July 18, 1985  
ST-HL-AE-1298  
File No.: G4.2

South Texas Project  
Units 1 & 2  
Docket Nos. STN 50-498, STN 50-499  
Closeout of ICSB Meeting Item Regarding  
Auxiliary Feedwater Turbine Control

Marked-up FSAR Text  
Auxiliary Feedwater Turbine Control

Figure 7.3.21A

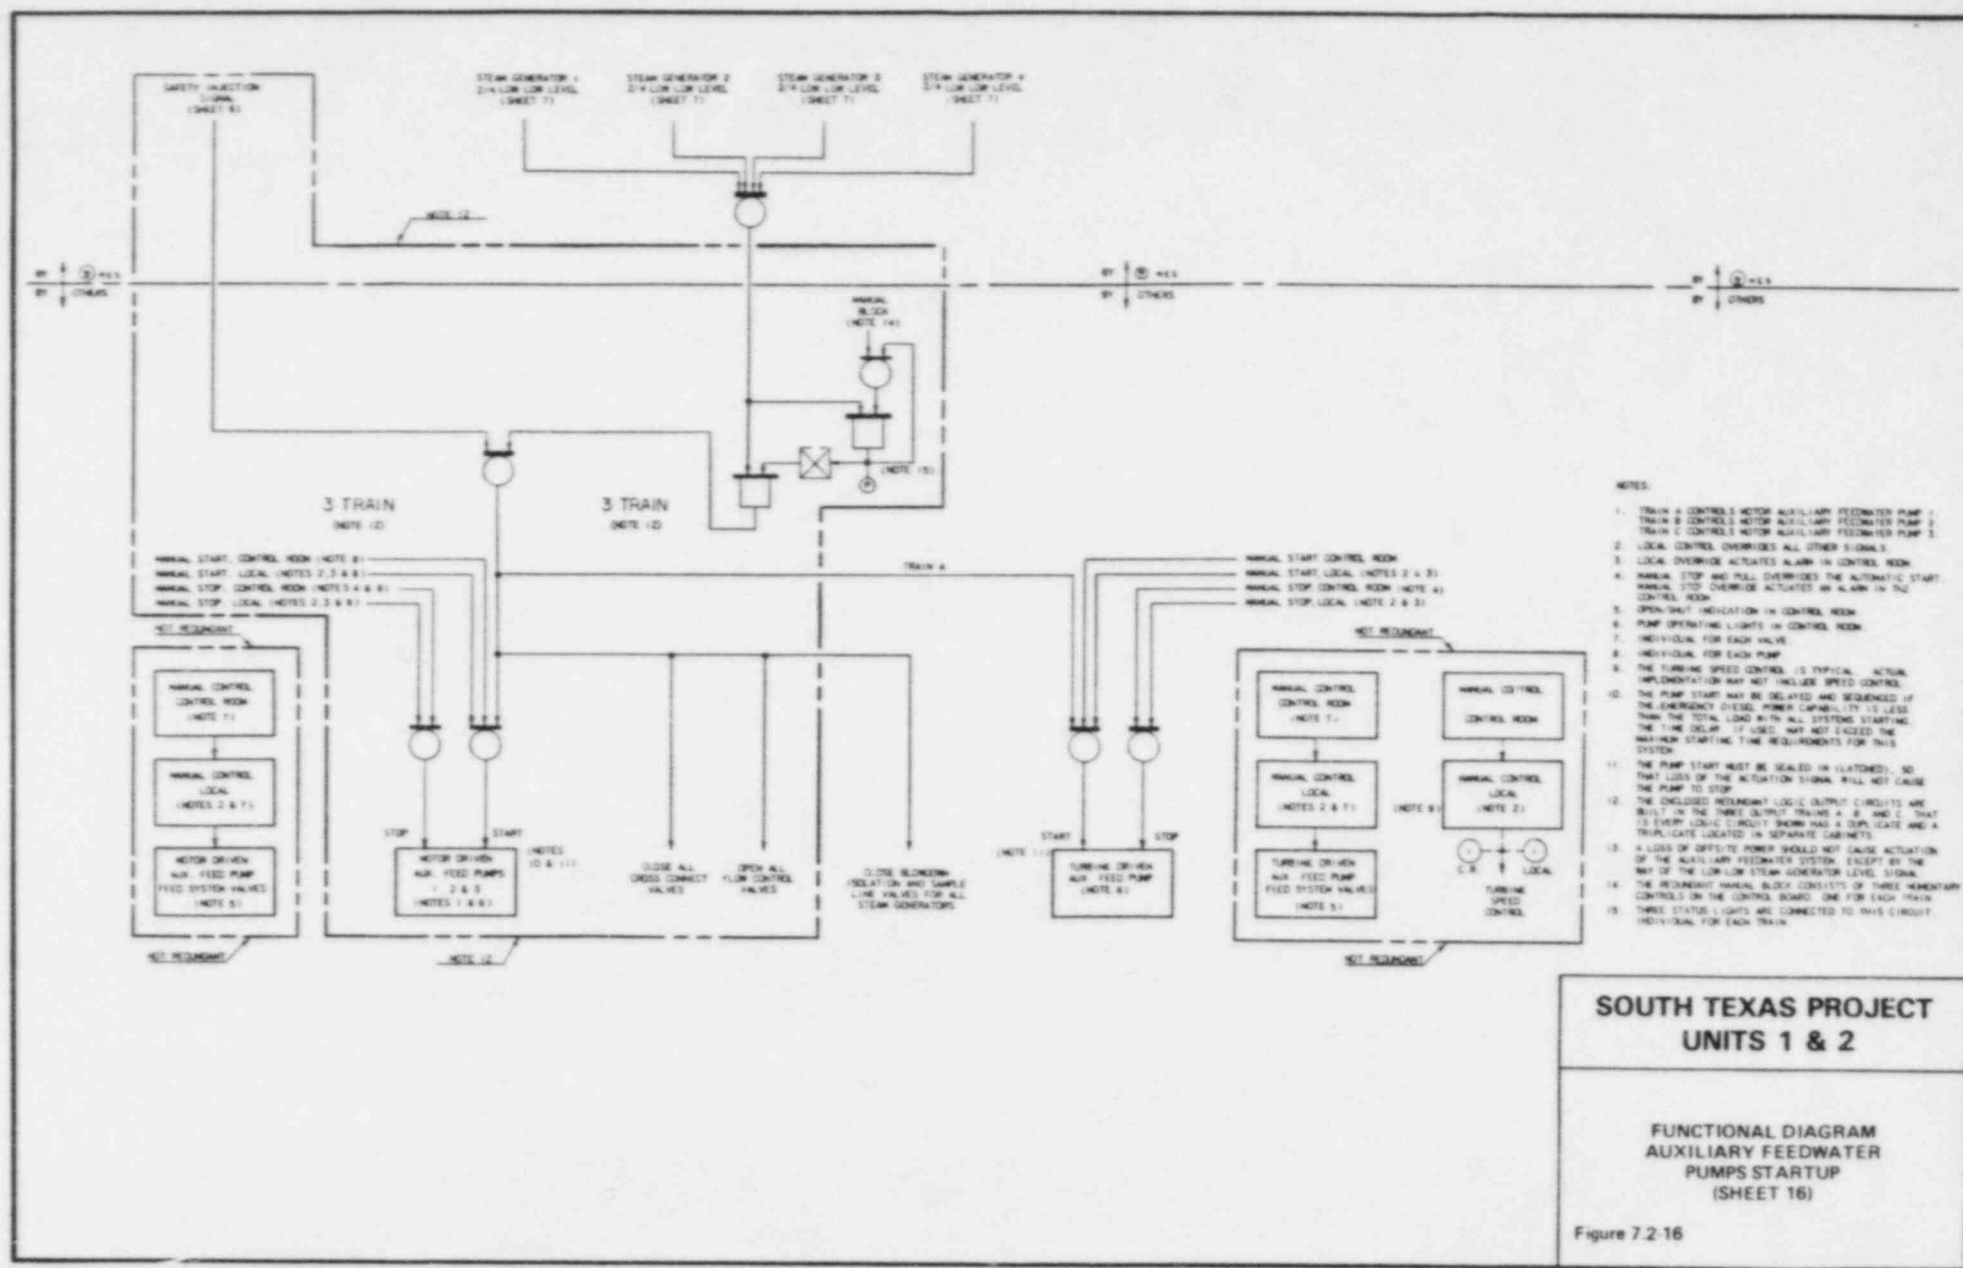
AFW TURBINE STEAM  
 INLET VALVE  
 SYSTEM: AF

Dwg. 5S14-9-Z-40132 Rev. 3

Figure 10.4.9-1

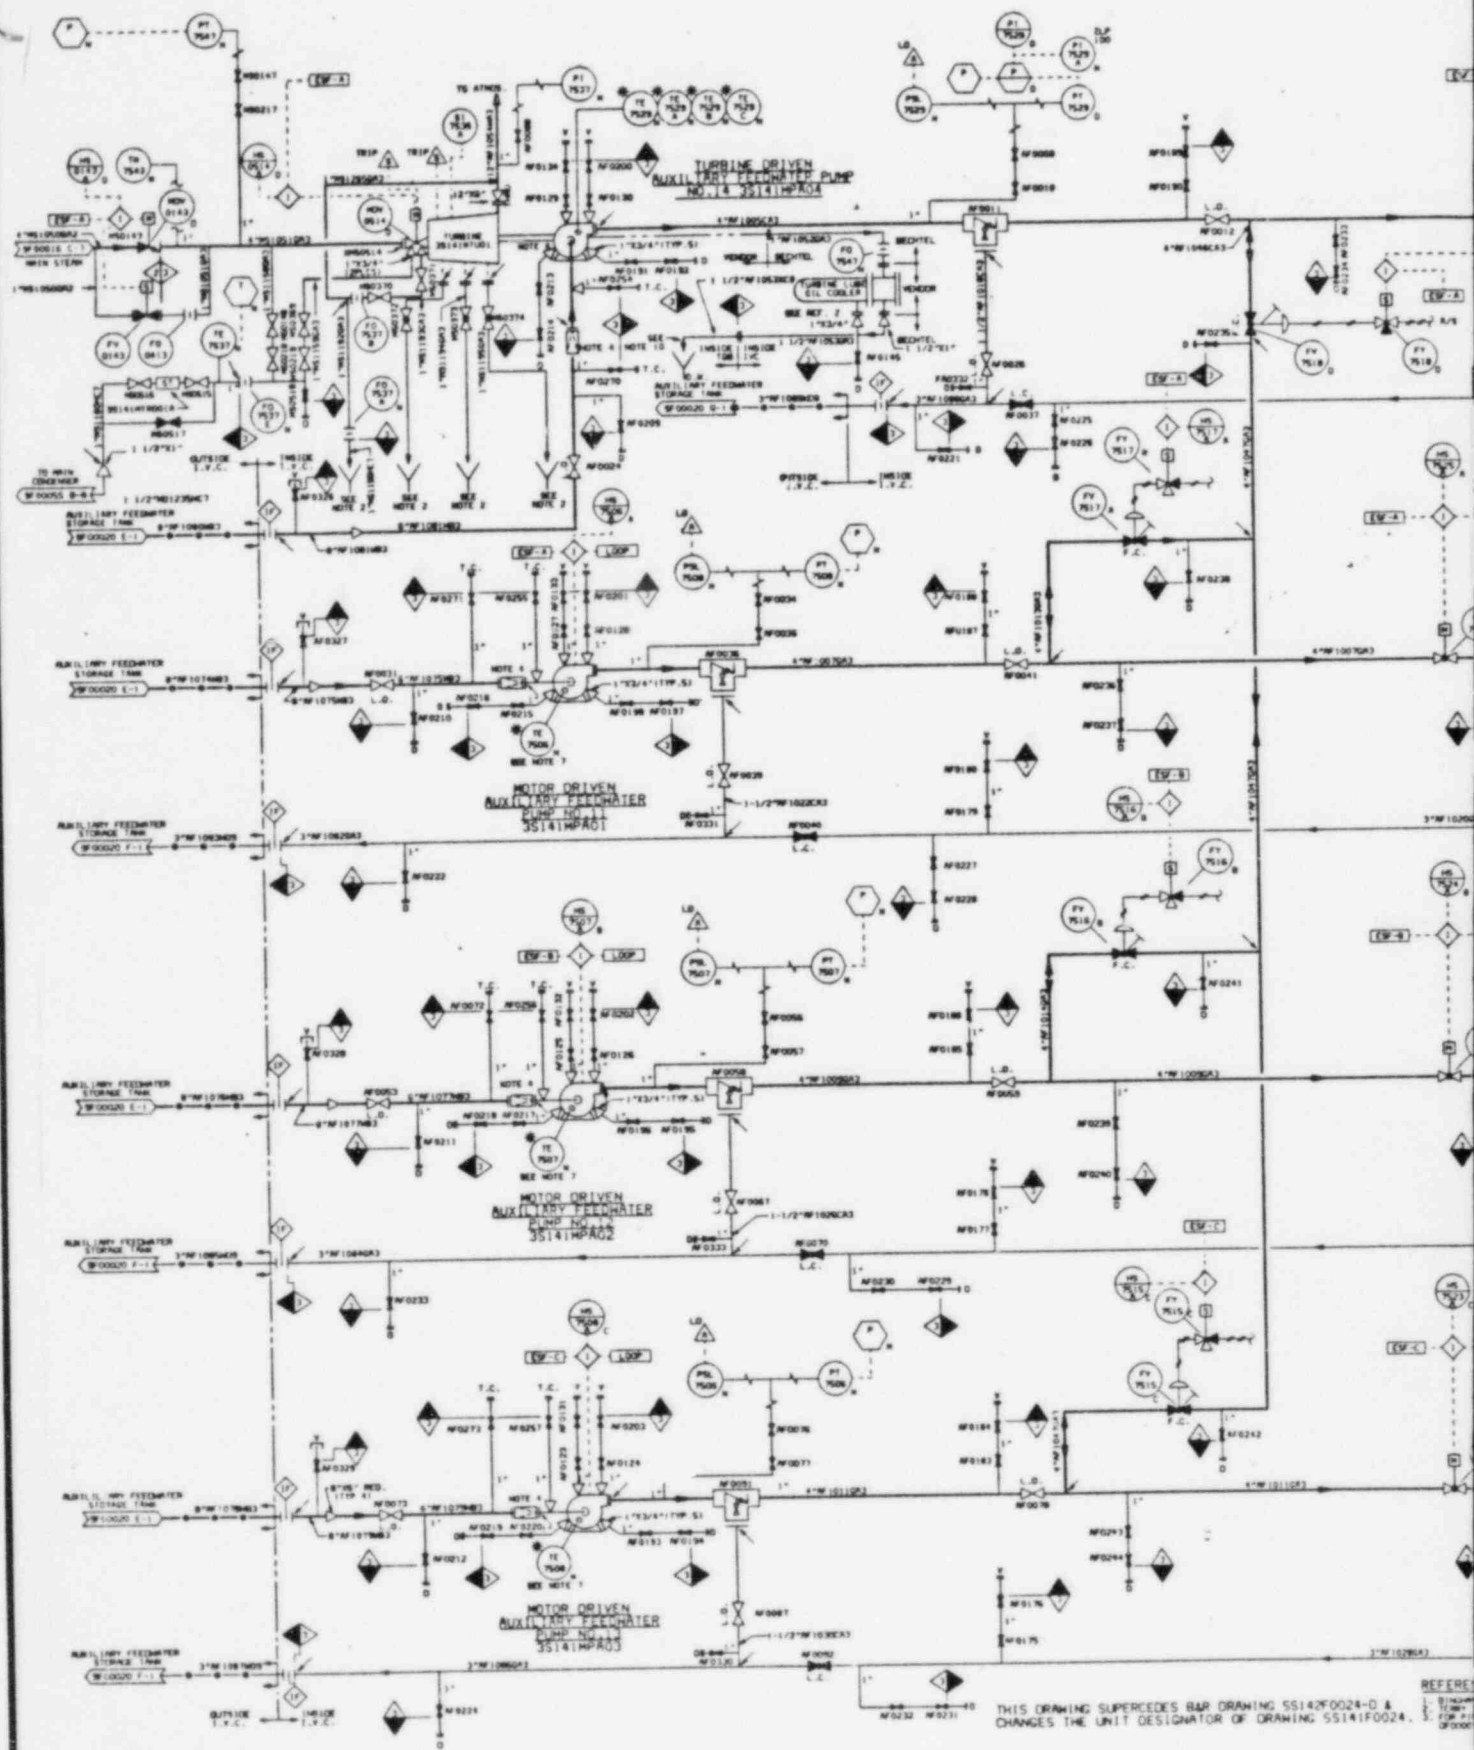
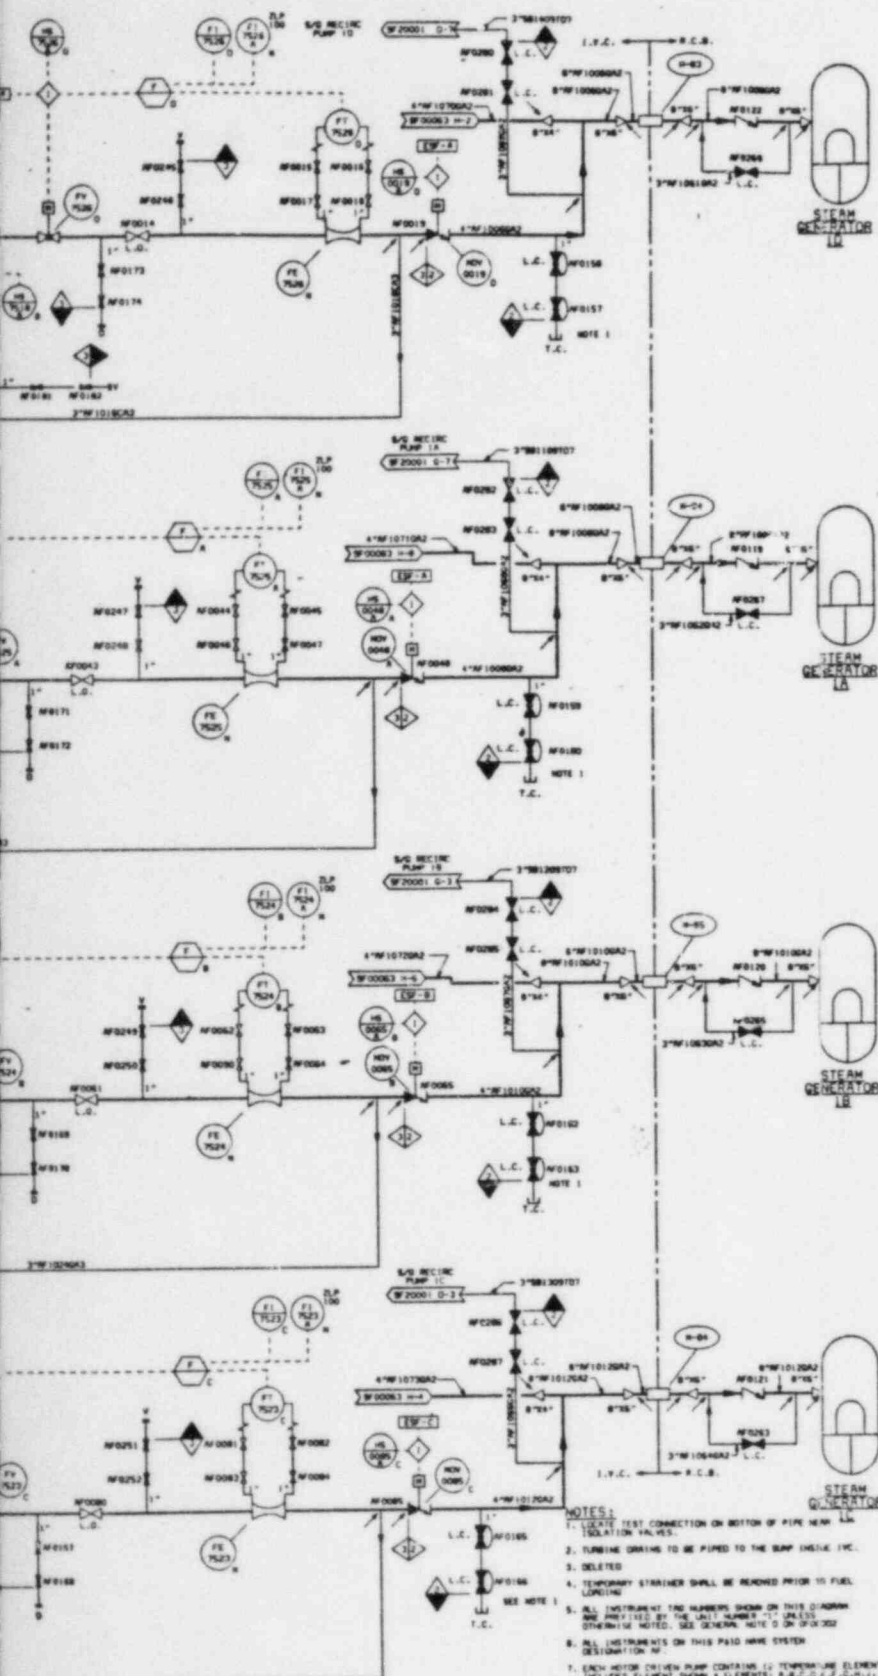
THIS DRAWING SUPERCEDES BAR DRAWING 55142F0024-D & CHANGES THE UNIT DESIGNATOR OF DRAWING 55141F0024.
